# **MCKINNEY 380 C&D LANDFILL**

# PERMIT MODIFICATION APPLICATION – WITH NOTICE NOD 2 RESPONSE

TCEQ MSW Permit No. 2278A Collin County, Texas

Parkhill Project # 016775.21

**FIG.III-11.1**

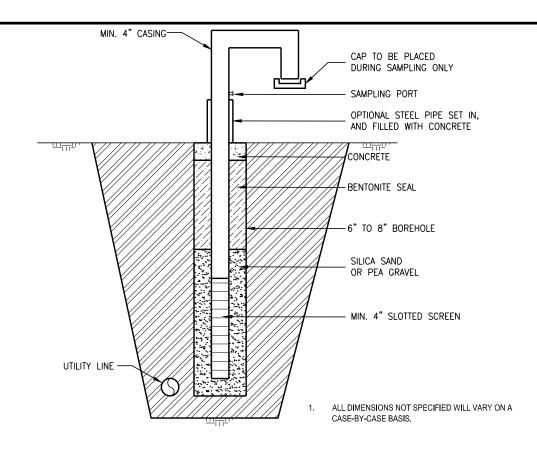
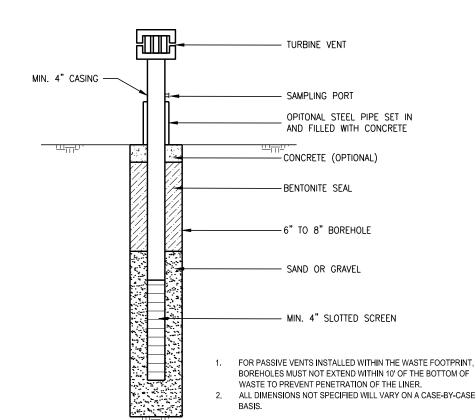
**Comment 7:** The revised Site Layout Plan (Figure III-4.5) indicates "All utility easements, including the sewer easement, are shown on Figure II-3.7 – Site Easements Map." The sanitary sewer easement indicated on the June 21, 2022 version of Figure II-3.7 appears to extend for at least 2,000 feet. Please explain how the proposed number, location, and spacing of the utility vents indicated on Figure III-4.5 dated October 1, 2024 will provide sufficient ventilation for the trench.

- Revising Figures III-4.5 and III-11.1 to indicate the locations of the proposed utility vents.
- Revising the LGMP to clarify requirements for installation and monitoring of passive vents for utility trenches that
  cross the landfill boundary.
- Revising the LGMP to include additional corrective measures for any future landfill gas exceedance remediation
  and specify requirements for more frequent monitoring in the event of a landfill gas exceedance in a perimeter
  probe.
- Adding new Figures III-11.2 and III-11.3 to include typical details for landfill gas perimeter monitoring probes, passive vents, interceptor trenches, and bar probes.

**Response:** 30 TAC §330.371(b)(1)(E) requires landfill units to implement a routine methane monitoring program to ensure that the concentration of methane gas does not exceed 5% by volume in monitoring points, probes, subsurface soils, or other matrices at the facility boundary as defined in the permit. Additionally, 30 TAC §330.371(f) mandates venting of any underground utility trenches that cross the landfill facility boundary.

While there is no explicit rule requirement specifying the location, number, or spacing of vents for underground utility trenches, it is standard industry practice to install vents at the points where underground utility trenches cross the landfill facility boundary. This approach facilitates venting within the landfill boundary and ensures compliance with 30 TAC §330.371(b)(1)(E). The proposed number and locations of vents in Figure III-4.5, are based on this standard practice and are designed to monitor and mitigate potential methane accumulation.

To address the concern about sufficient ventilation for the trench, if methane concentrations exceeding the regulatory limit are detected at the proposed utility vent locations, the owner/ operator shall follow §330.371(c) to ensure human health and notify the Texas Commission on Environmental Quality (TCEQ), as required. A permit modification application will also be submitted to include additional vents or other measures as necessary to ensure compliance with 30 TAC §330.371.

Revised Figure III-11.1 to remove references to excavation contours and depth from notes. Excavation contours are not shown on this figure.

Revised Figure III-11.1 to add note 5 stating that vent locations are approximate and maybe adjusted as necessary.
